Department of Public Works
Engineering Division

**CITY OF BERKELEY
FY 2025 DRAINAGE IMPROVEMENTS PROJECT
SPECIFICATION NOS. 23-11561-C AND 25-11677-C
ADDENDUM NO. 1**

ADDENDUM#1	05-29-25	APPROVAL
BID SET	09-28-23	
95% SUBMITTAL	07-27-23	
65% SUBMITTAL	10-27-22	
DESCRIPTION	DATE	MARK
REVISION		
PLAN 8279		
FILE 502-718		
C2.1		
SHEET 6 OF 35

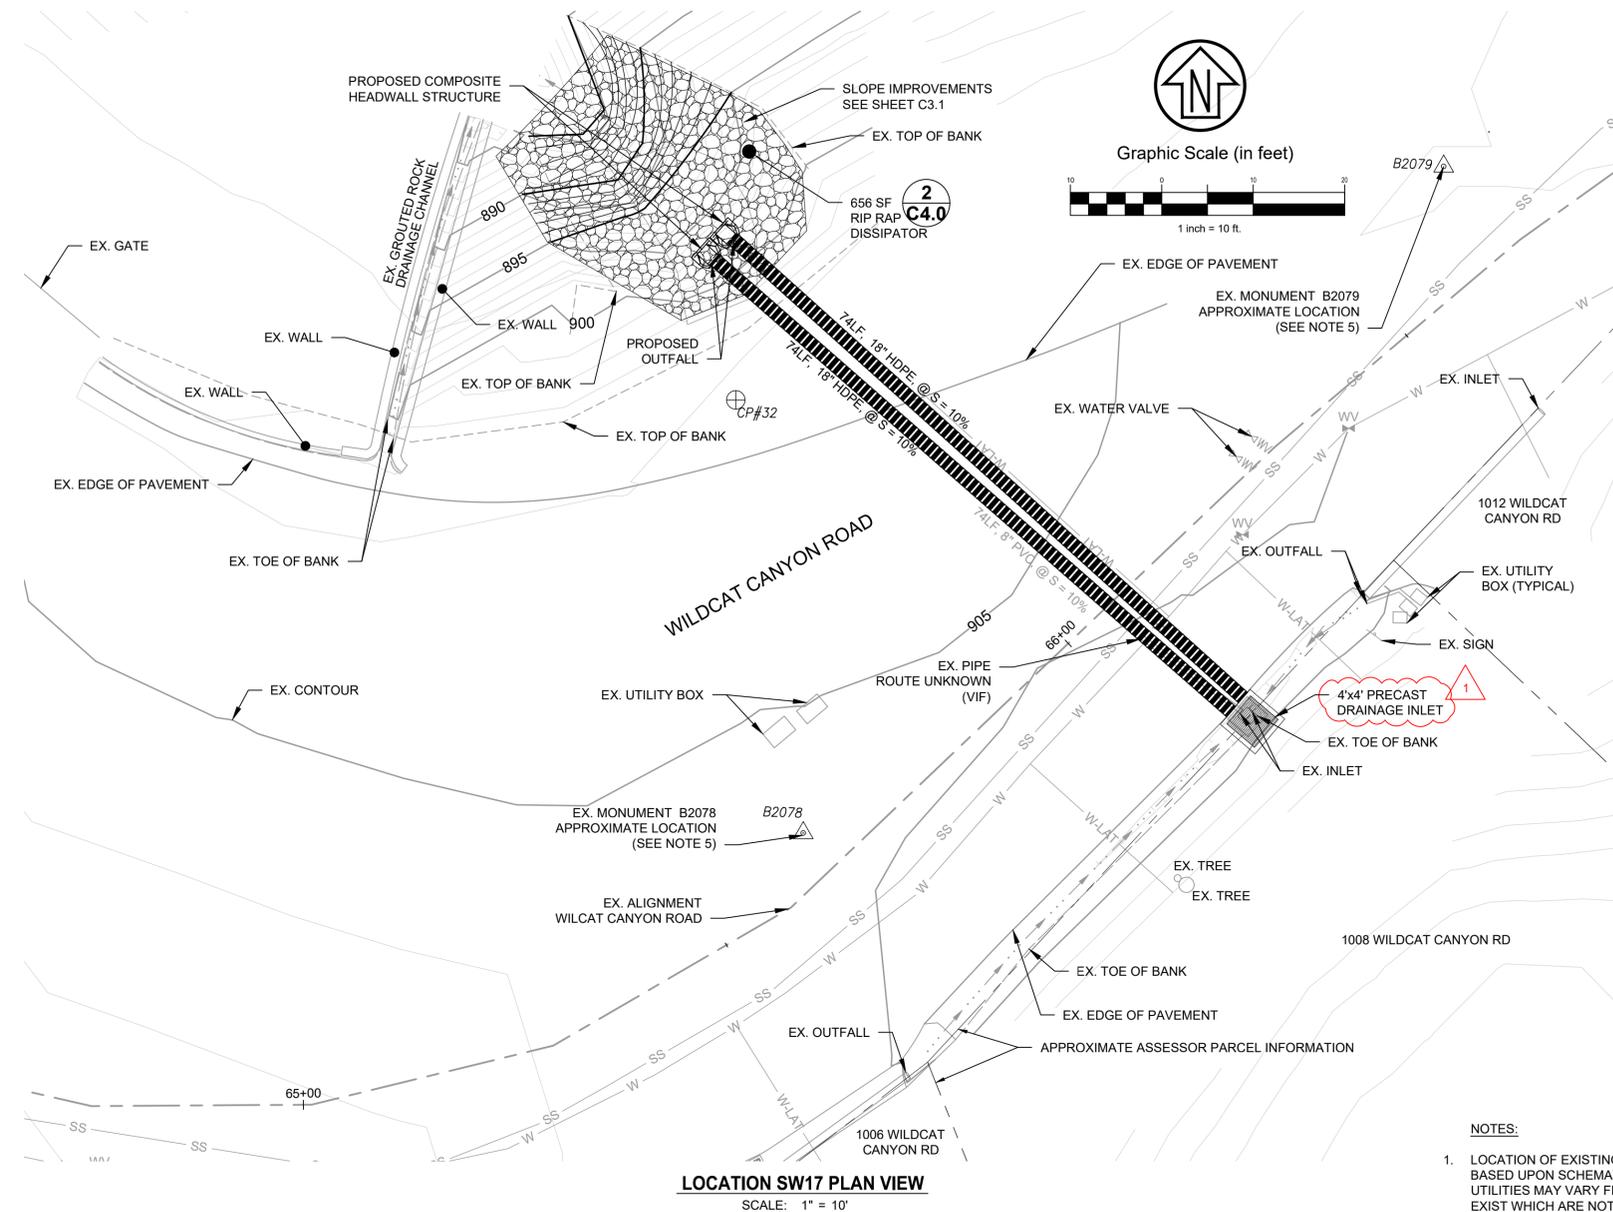
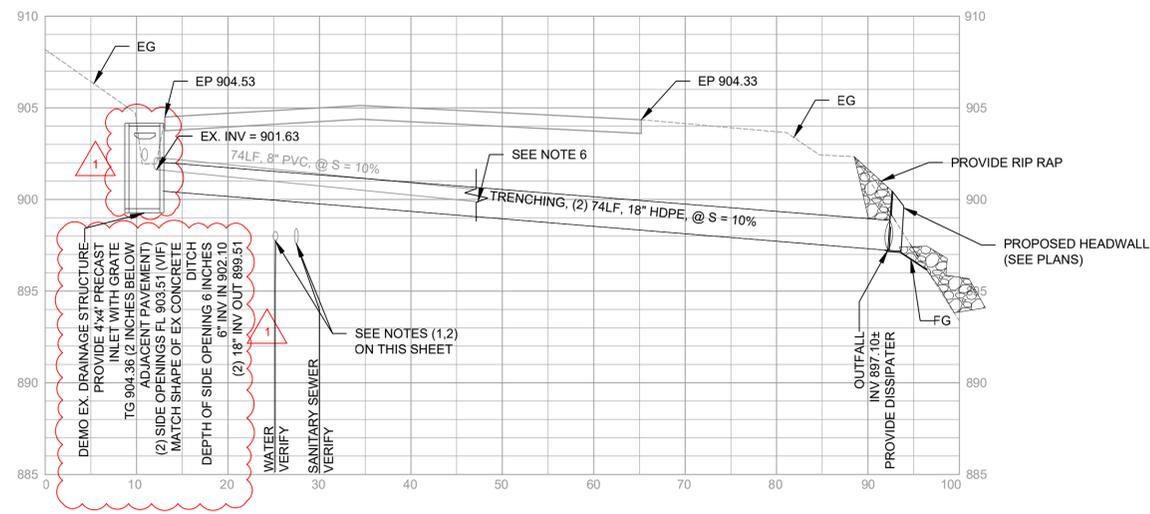
NOTE:
ALL WORK ON THIS SHEET (LOCATION SW2) IS REVOCABLE FOR BIDDING PURPOSES.
